North Campus Townhouse Units Renovations - 2020

Project Number: SCSU-2020-04

ADDENDUM NO. 1

June 15, 2020

Drawing PFP1 – Partial First and Second Floor – Plumbing/Fire Protection Plans – 1 Sheet

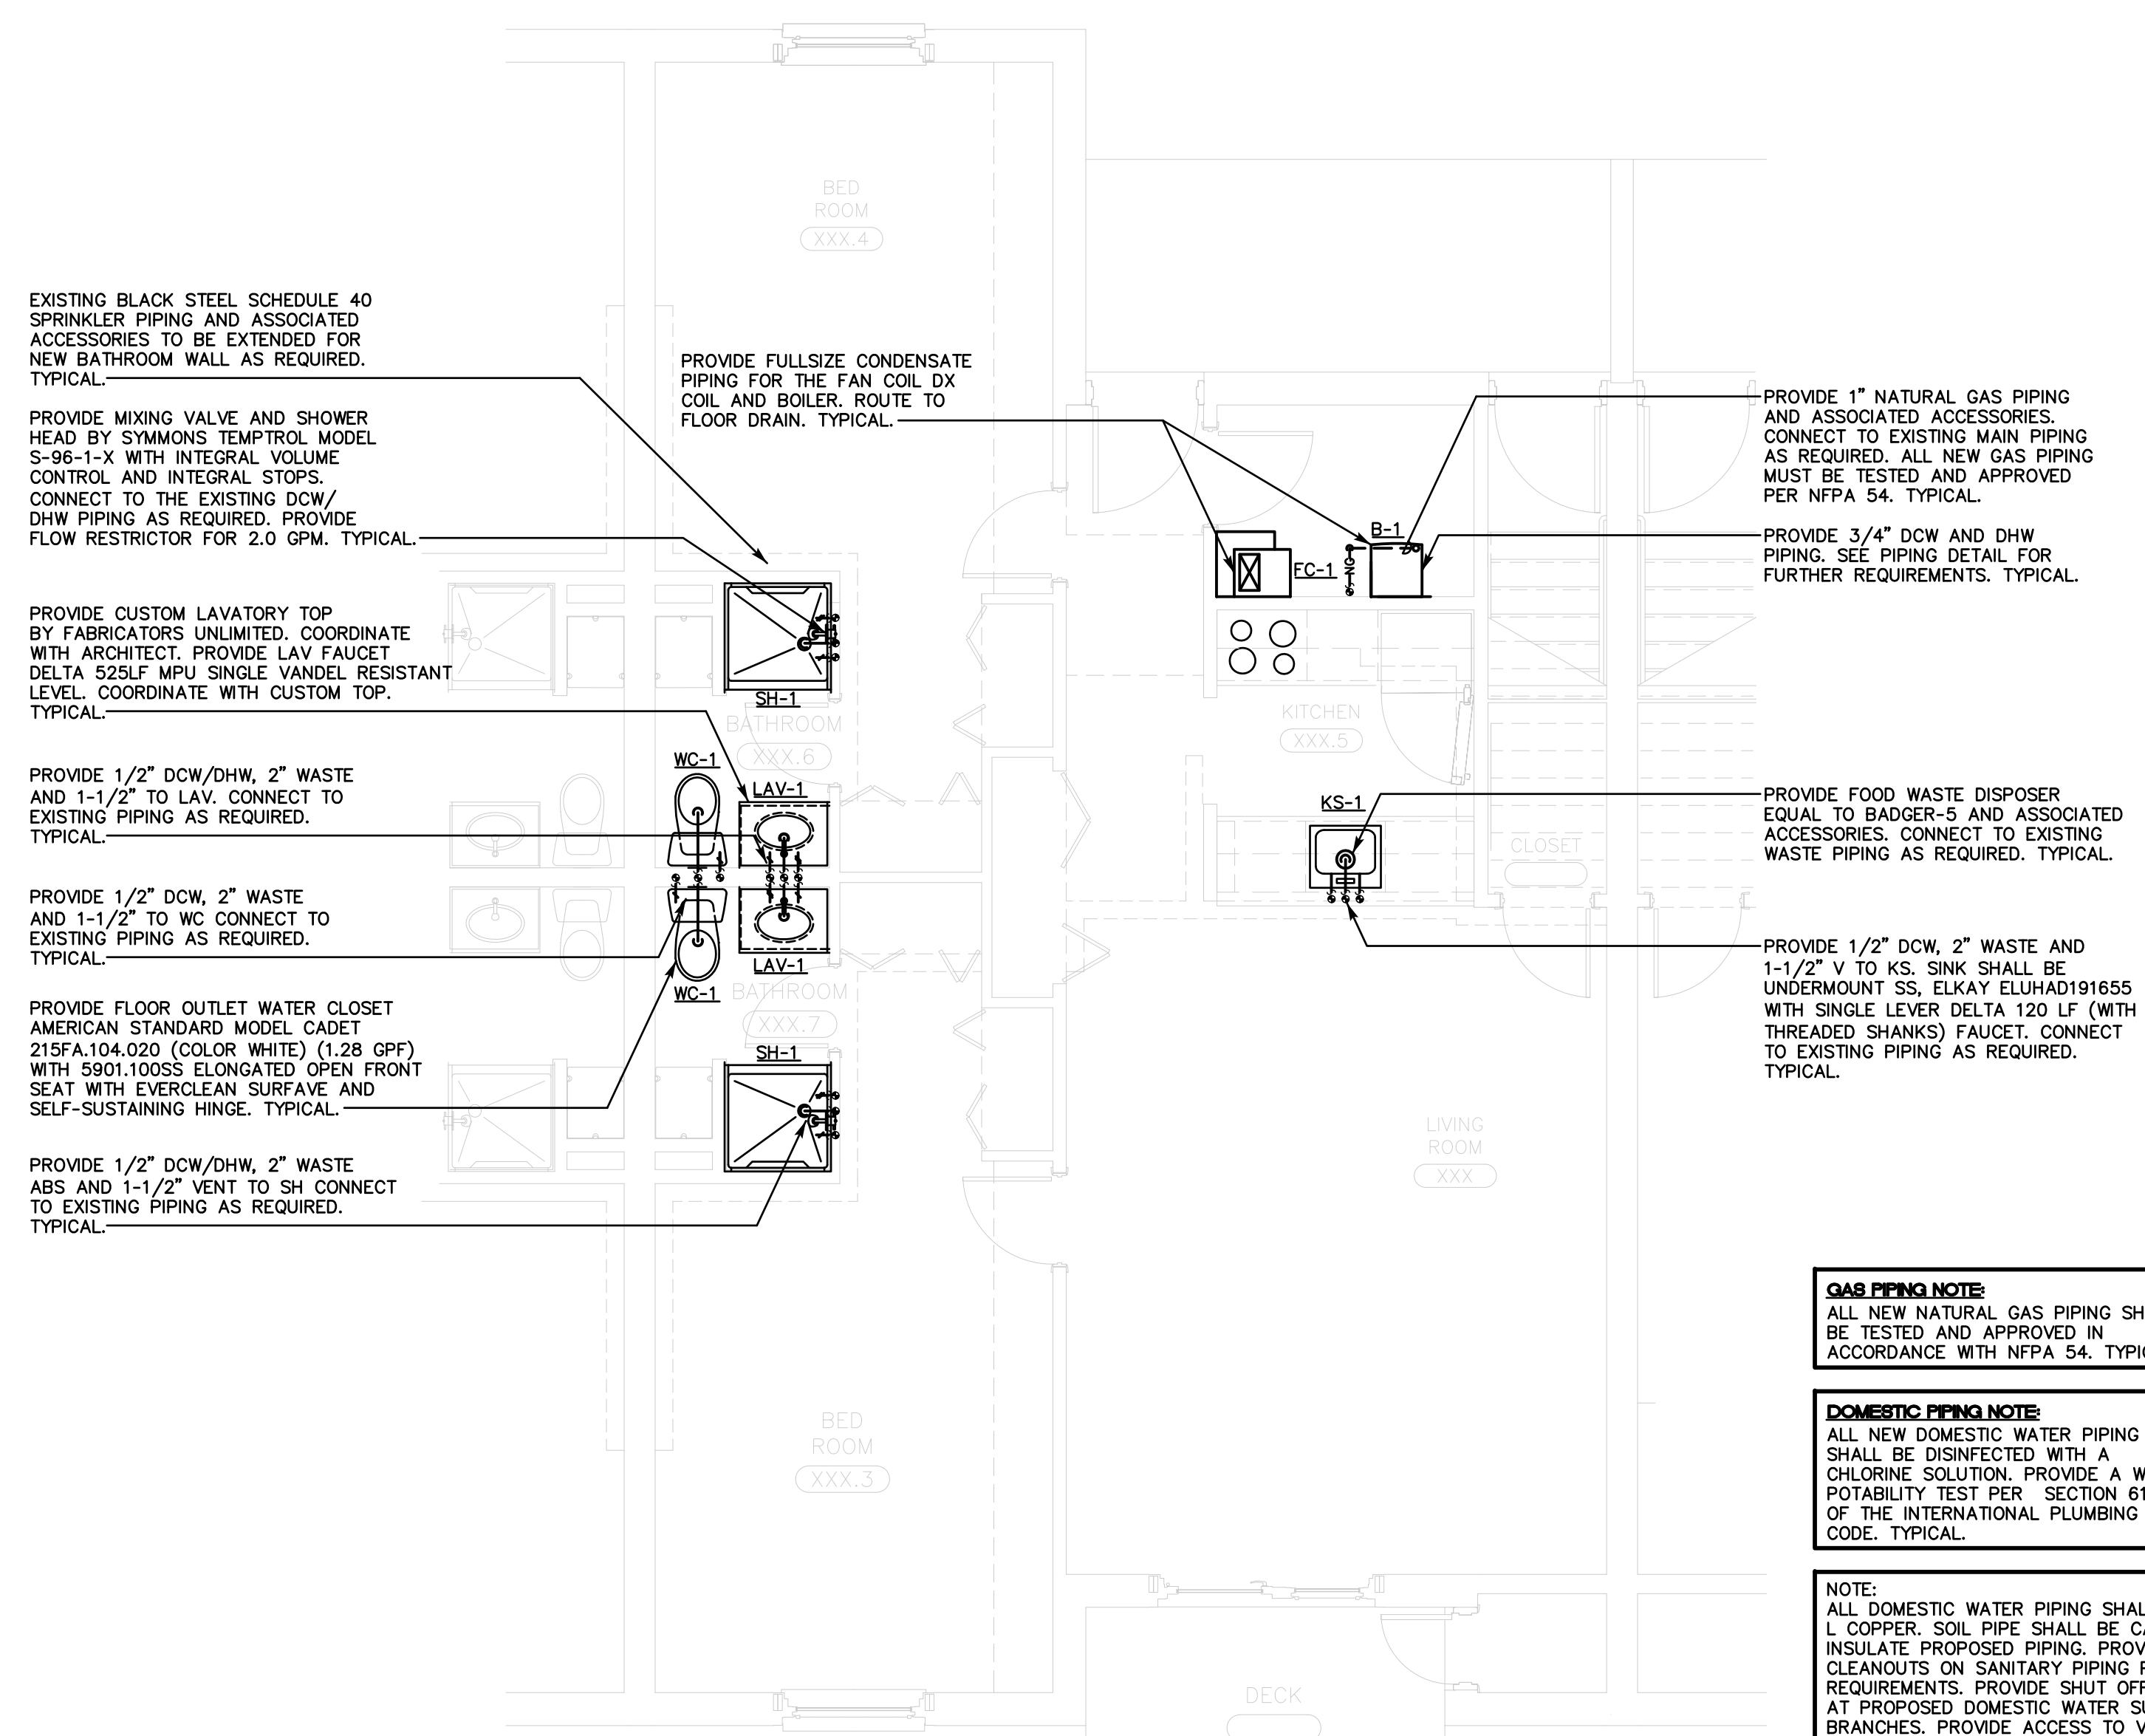
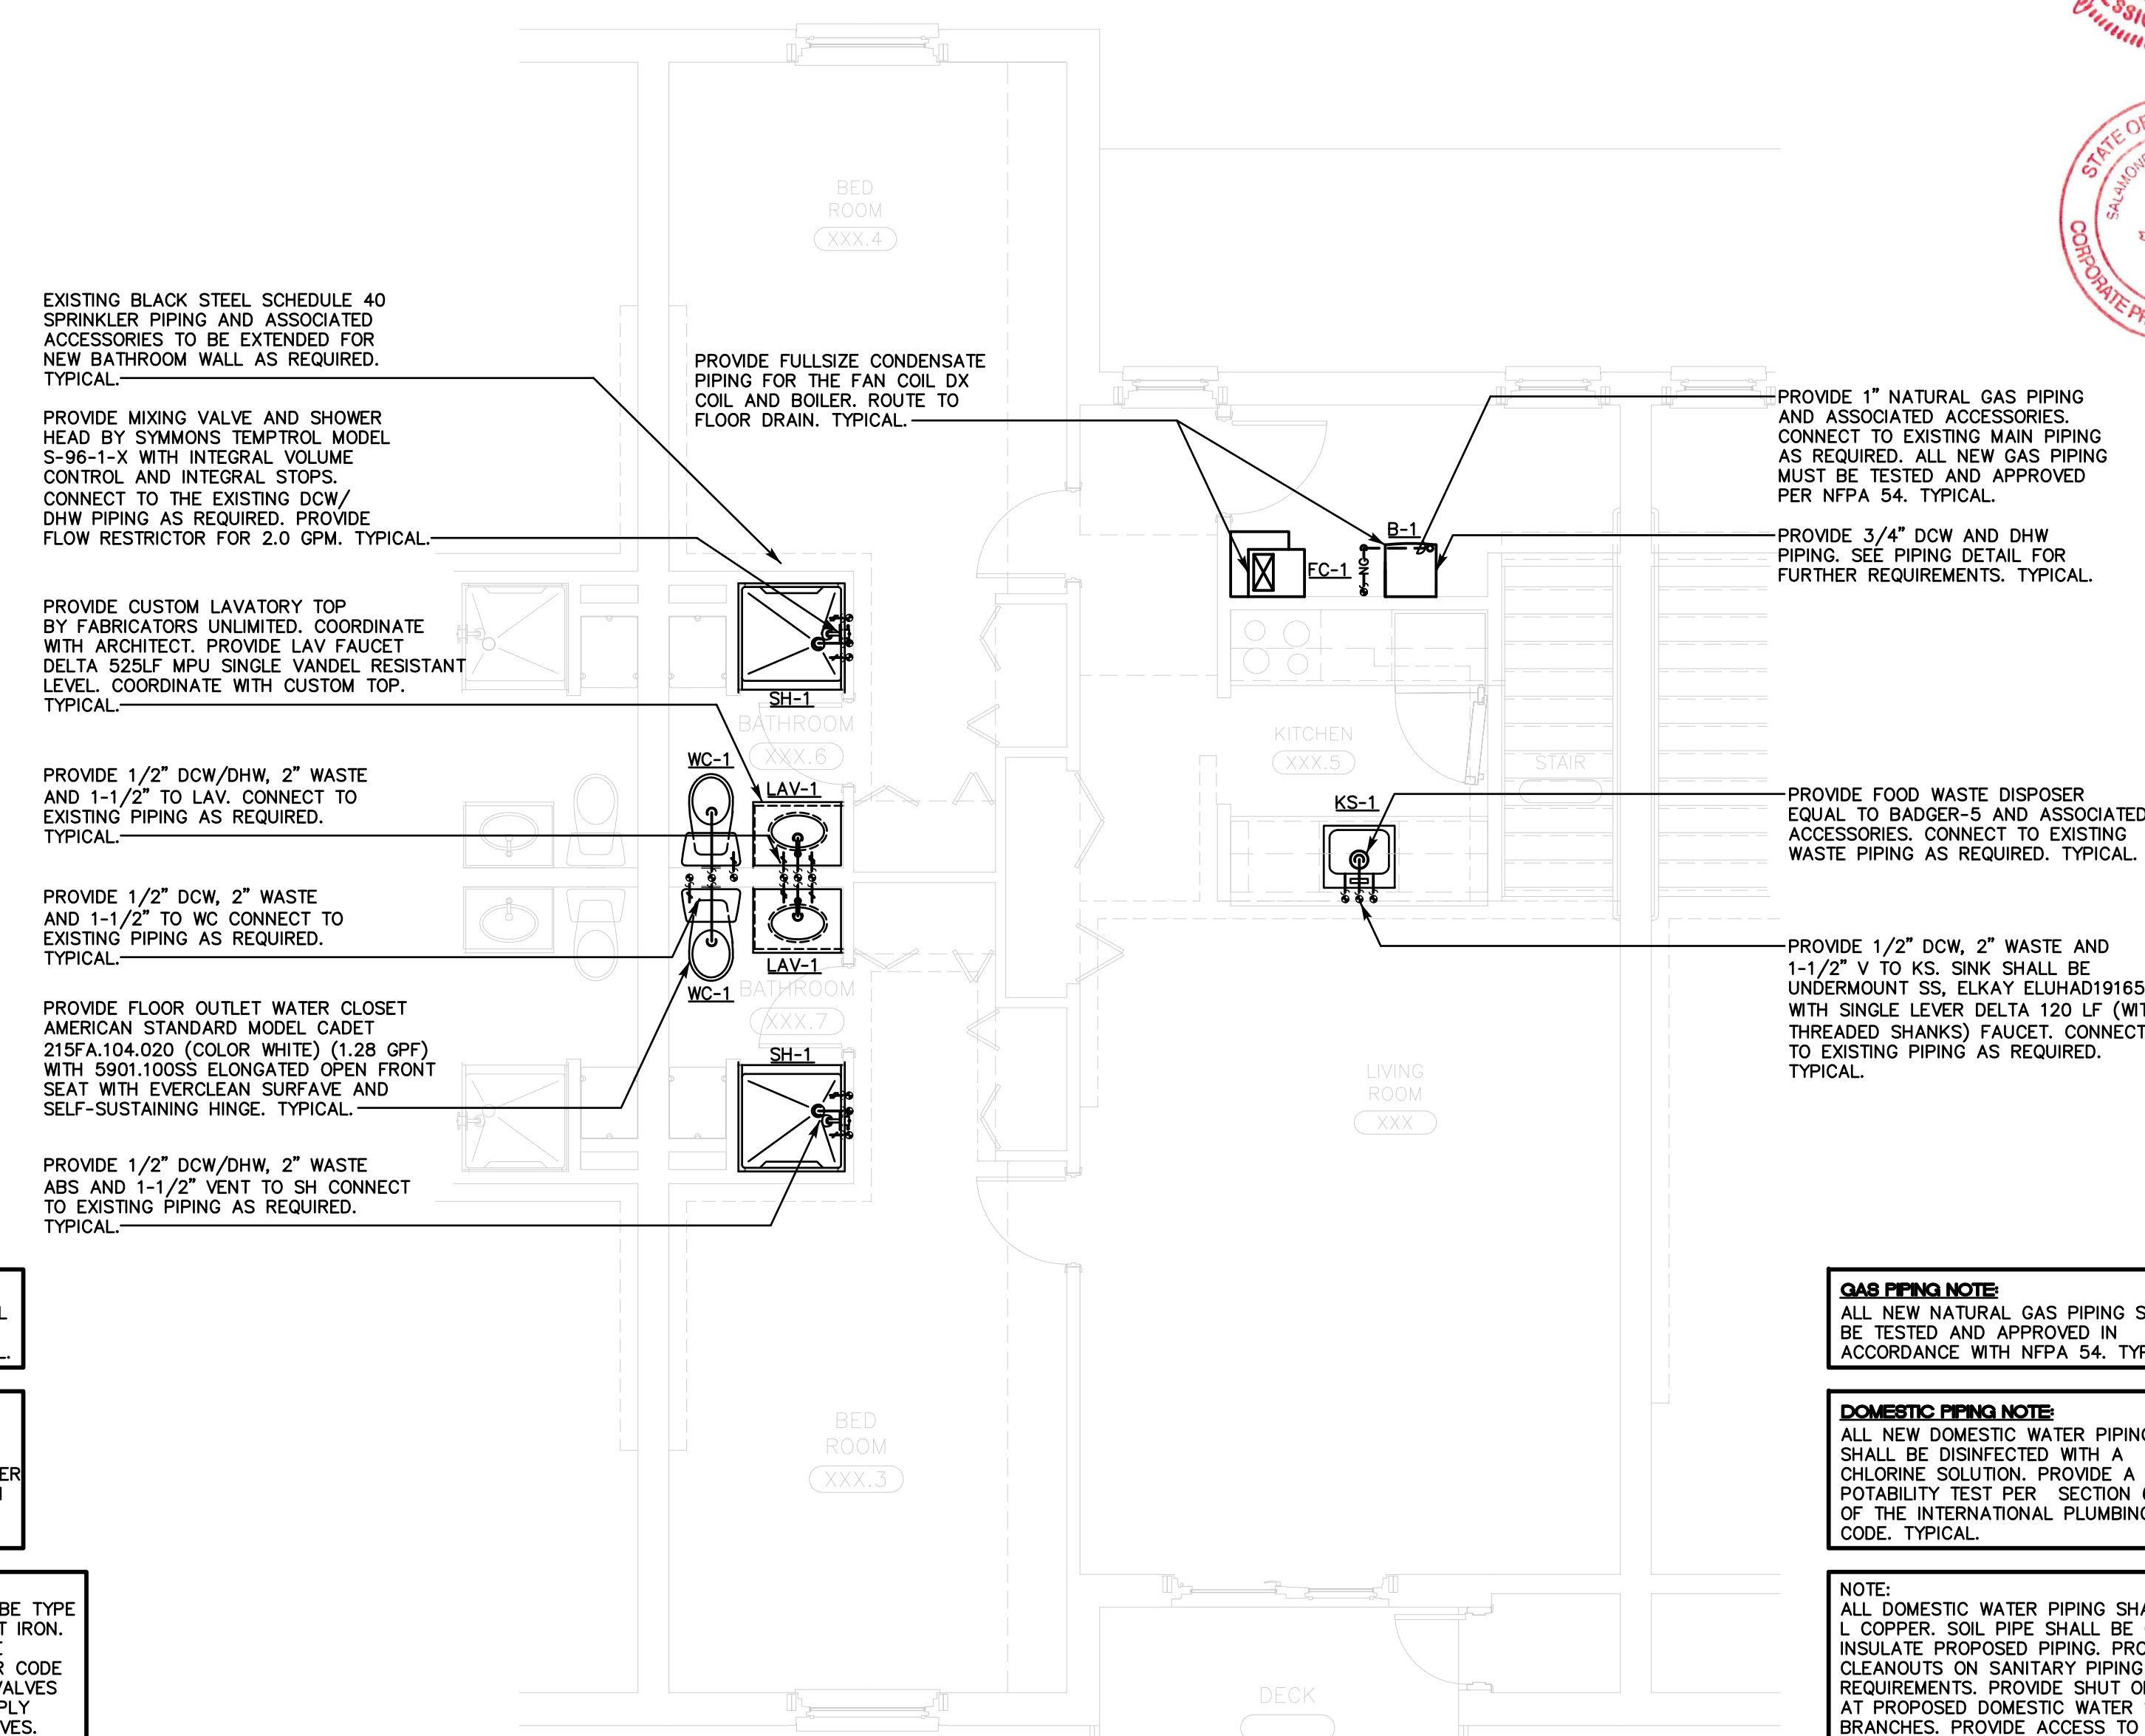
Item 7 DRAWING PFP1 – PARTIAL FIRST AND SECOND FLOOR – PLUMBING/FIRE PROTECTION PLANS
See attached Drawing. The Description of the Domestic Water Piping Testing Requirements has been added.

DOMESTIC WATER PIPING TESTING REQUIREMENTS
THE CONTRACTOR SHALL UPON COMPLETION OF A SECTION OF OR THE ENTIRE WATER SUPPLY SYSTEM, THE SYSTEM, OR PORTION COMPLETED SHALL BE TESTED AND PROVED TIGHT UNDER A WATER PRESSURE NOT LESS THAN THE WORKING PRESSURE OF THE SYSTEM, OR FOR PIPING SYSTEMS OTHER THAN PLASTIC AN AIR TEST OF NOT LESS THAN 50 PSI (344 kPa). THIS PRESSURE SHALL BE HELD FOR NOT LESS THAN 15 MINUTES. THE WATER UTILIZED FOR TESTS SHALL BE OBTAINED FROM A POTABLE SOURCE OF SUPPLY. THE REQUIRED TESTS SHALL BE PERFORMED IN ACCORDANCE WITH SECTION 312 AND SECTION 107 OF THE 2015 EDITION OF THE INTERNATIONAL PLUMBING CODE.

DOMESTIC WATER PIPING TESTING REQUIREMENTS
THE CONTRACTOR SHALL UPON COMPLETION OF A SECTION OF OR THE ENTIRE WATER SUPPLY SYSTEM, THE SYSTEM, OR PORTION COMPLETED SHALL BE TESTED AND PROVED TIGHT UNDER A WATER PRESSURE NOT LESS THAN THE WORKING PRESSURE OF THE SYSTEM, OR FOR PIPING SYSTEMS OTHER THAN PLASTIC AN AIR TEST OF NOT LESS THAN 50 PSI (344 kPa). THIS PRESSURE SHALL BE HELD FOR NOT LESS THAN 15 MINUTES. THE WATER UTILIZED FOR TESTS SHALL BE OBTAINED FROM A POTABLE SOURCE OF SUPPLY. THE REQUIRED TESTS SHALL BE PERFORMED IN ACCORDANCE WITH SECTION 312 AND SECTION 107 OF THE 2015 EDITION OF THE INTERNATIONAL PLUMBING CODE.
